PCN: V16-002-476103-OA

Product Change Notice

Standardize Glass Codewheel (CW) top surface printing artwork material process from Chrome Oxide to Chrome.

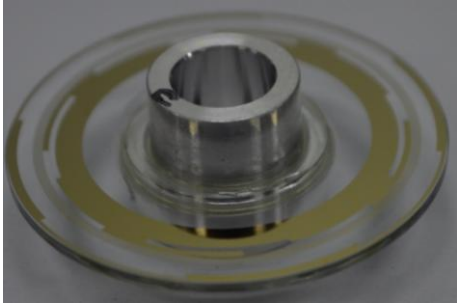
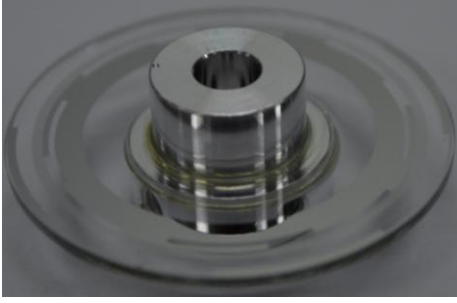
Item	Top View	Bottom View	Remarks
<p>Present CW Artwork Printing</p>	 <p>Top Artwork Gold Color</p>	 <p>Bottom Artwork Silver Color</p>	<p>Top surface printing material is Chrome Oxide (Gold Color) and bottom surface material is Chrome (Silver Color)</p>
<p>New CW Artwork Printing</p>	 <p>Top Artwork Silver Color</p>	 <p>Bottom Artwork Silver Color</p>	<p>Change top surface printing material from Chrome Oxide to Chrome (Silver Color)</p> <p>Retain similar bottom printing surface material Chrome (Silver Color)</p>

Standardize top surface printing artwork material from Chrome Oxide to Chrome. There is no change with total thickness of the coating, optical density, reflectivity and scratch resistant.
